Technical Service Bulletin: TSB180174

Thin Wall Block Condition

- QSK19 CM500
- QSK19 CM850
- QSK19 CM2150

Figure 1, Coolant Port Measurement Location.

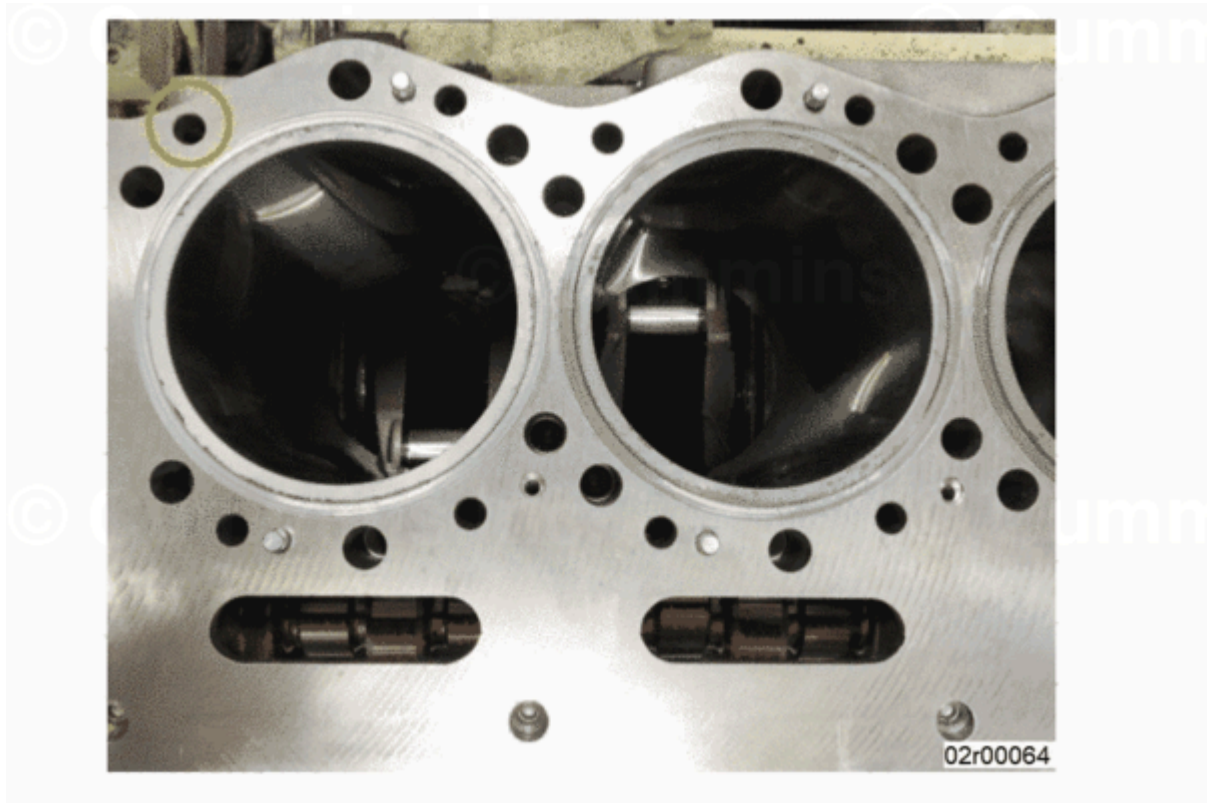
- Confirm leak location is cylinder number 1 forward coolant port. See Figure 1 below.
- After removing cylinder head, measure cylinder block wall thickness between coolant drilling and outer edge of cylinder block. Use calipers to measure cylinder block wall thickness. See Figure 2 below.

- Industrial application cylinder blocks with a measurement between 3.25mm [0.128in]and 5mm [0.197in] use head gasket Part Number 3634664.
- Rail application cylinder blocks with a measurement between 4.25mm [0.167in] and 5mm [0.197in] use head gasket Part Number 3634664.
- For cylinder blocks with a measurement of over 5mm, use cylinder head gasket Part Number 4334080.
